July 11, 2011

C8051F54x Errata

Errata Status Summary

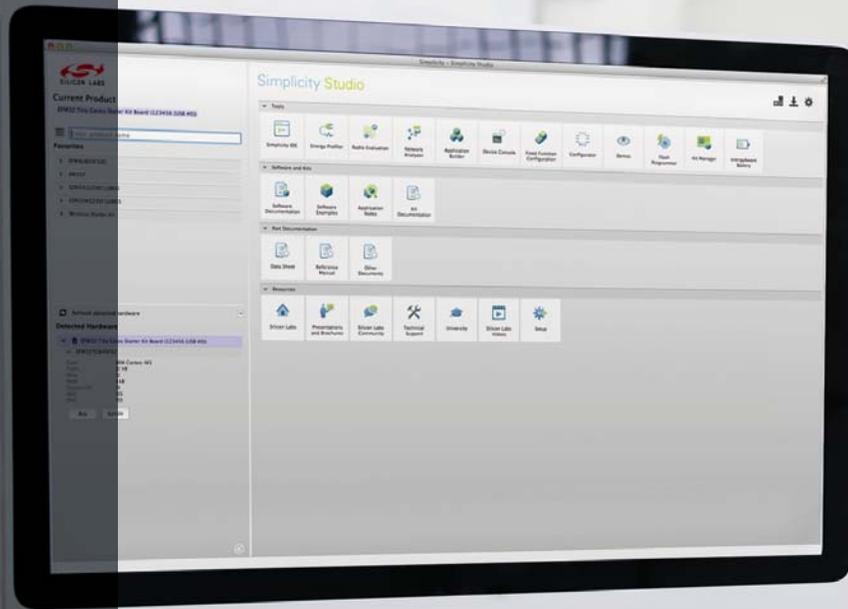
- Description:** If the /RST pin is held low for more than 1 second while power is applied to the device, and then /RST is released, a percentage of devices may “lock up” and fail to execute code. Toggling the /RST pin does not clear the condition. The condition is cleared by cycling power. Most devices that are affected will show the lock up behavior only within a narrow range of temperatures (a 5 to 10 °C window).

Impacts: Devices that lock up due to this issue will fail to execute code until the next power-on reset.

Workaround: Ensure that the reset low time does not exceed 1 second.

Resolution: Silicon Labs has identified a solution to this problem and this solution has been tested and qualified. Parts with the fix do not have any restrictions on /RST low time. The silicon revision remains the same, but Revision A parts that implement the fix can be identified visually using the assembly date code marking on the device. A four-digit assembly build date code is marked on each part on the bottom-most line. This is in the format YYWW, where YY is the two-digit assembly build calendar year and WW is the two-digit assembly build work week. All parts that have an assembly date code of 1124 or later (year 2011, work week 24) do not have any restrictions on /RST low time.
